Providence Bicycle and Pedestrian Advisory Commission

Staff Report: Emmett Square Conceptual Review – Downtown – Ward 1 (For Action)

Presented at November 15, 2018 BPAC meeting

The City of Providence Department of Planning and Development seeks comments from the BPAC regarding 30% plans for an extension of the Fountain Street bike lane across Dorrance Street. This will be a design level review of the project and will be the second of two reviews before the Commission.

Project Map

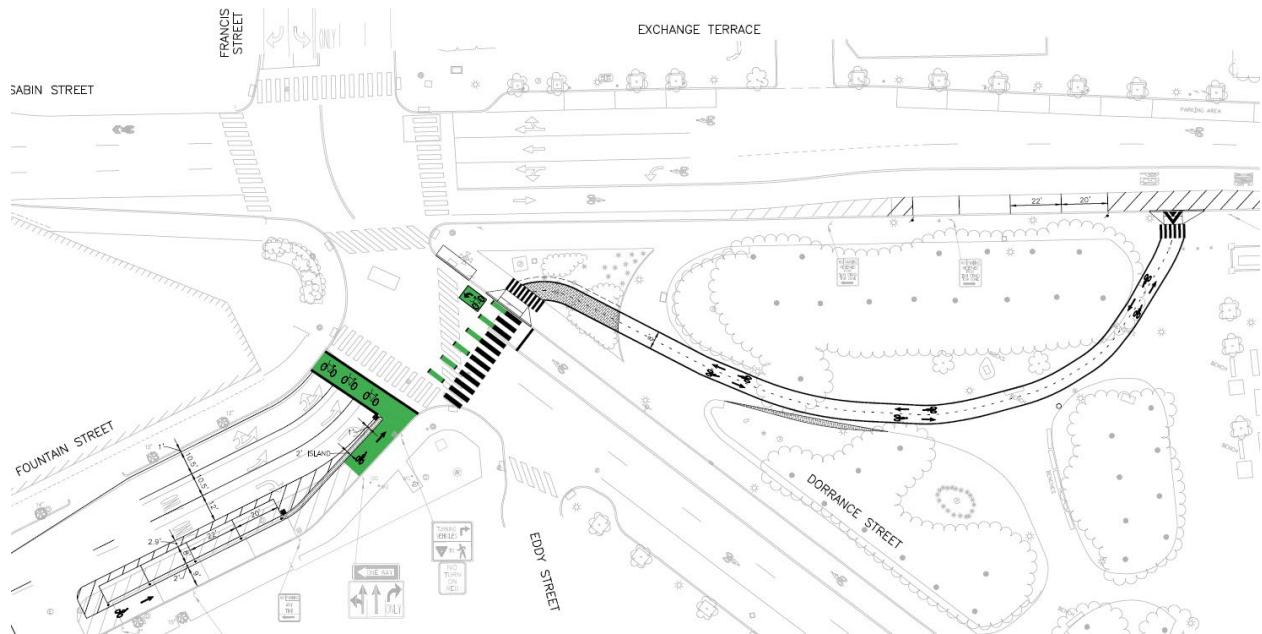
- On the Fountain Street approach to the crossing, the bike lane will remain in the roadway rather than going up on the sidewalk, in line with BPAC's recommendation.

- Because of this, the project does not need to build a new curb ramp on the southern corner of Dorrance St between Fountain St & Eddy St, but can re-use the existing curb ramps.

- Keeping the bike lane in the roadway requires restricting right turns from Fountain Street to use a right turn arrow signal. The pedestrian crosswalk as well as the bicycle crossing would operate at the same time as through vehicular traffic while right-turning vehicular traffic have a red arrow. The bike/ped phase would stop, and then the right-turning vehicles would have a green arrow while through traffic remains green as well.

- The path through Biltmore Park remains, but is now two-way. The steepness of the slope, the specific vehicular traffic details of Exchange Terrace, and the insufficient unobstructed width of the Exchange Terrace sidewalk along Biltmore Park made it infeasible to follow BPAC's recommendation to minimize the path's route through the park. See below for recommendations to limit bike/ped conflicts in the park.

- A two-stage turn box is included on Dorrance St adjacent to the bike crossing to allow either direction of bicyclists to continue safely onto Francis St or Sabin St.

- The path through Biltmore Park should be marked and signed as a shared-use path for use by bicyclists, pedestrians, and other nonmotorized modes. This should include a multimodal marking in development as part of City Walk as well as signage for bicyclists instructing them to slow down and yield to pedestrians upon entering the park, such as that pictured at right.
